A d d e n d u m

Iowa Department of Transportation
Office of Contracts

Date of Letting: March 17, 2015
Date of Addendum: March 13, 2015

B.O.	Proposal ID	Proposal Work Type	County	Project Number	Addendum
116	97-0297-048	PCC PAVEMENT - GRADE & REPLACE	WOODBURY	IM-NHS-029-7(048)149--03-97	17MAR116.A02

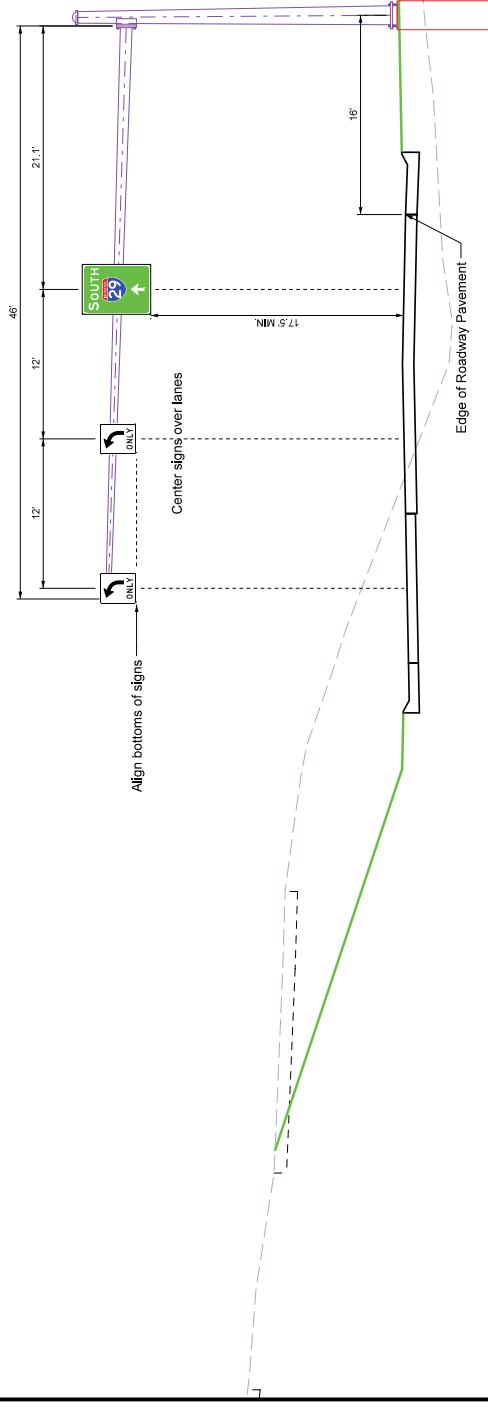
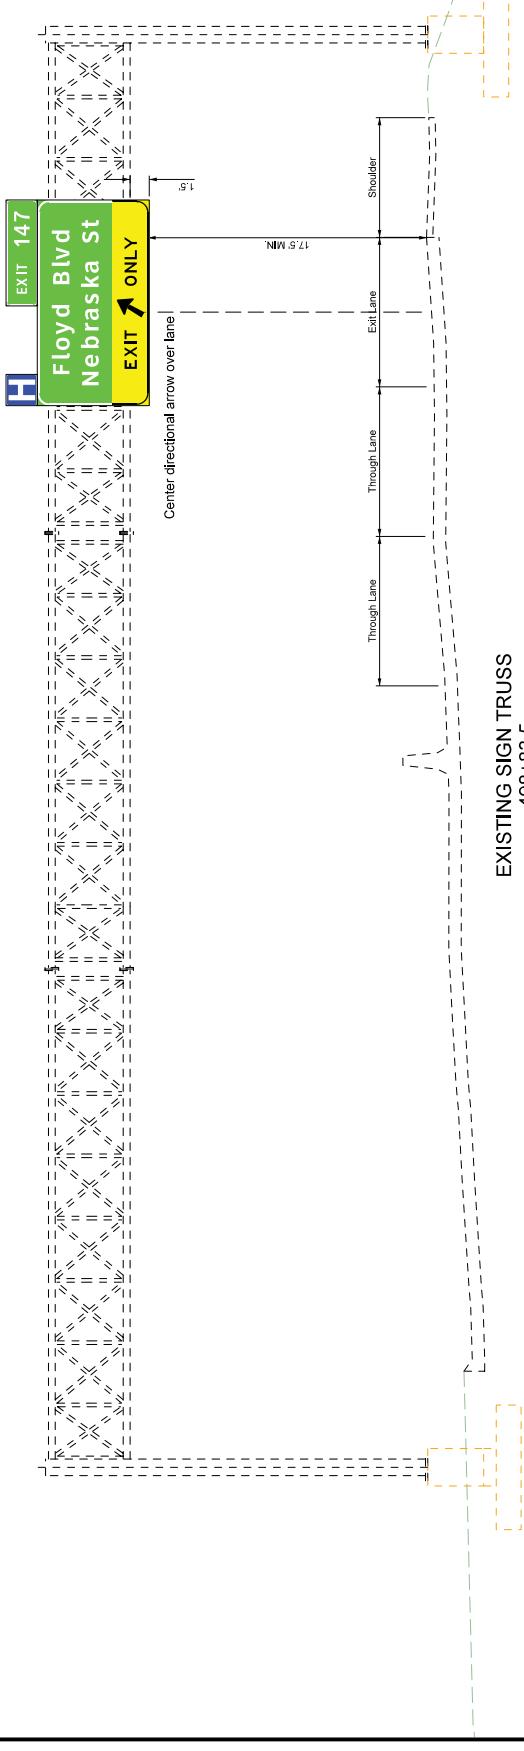
SHEET M.3

Replace Plan Sheet M.3 with the attached Plan Sheet M.3. Added Note 24 to tabulation 104-5B.
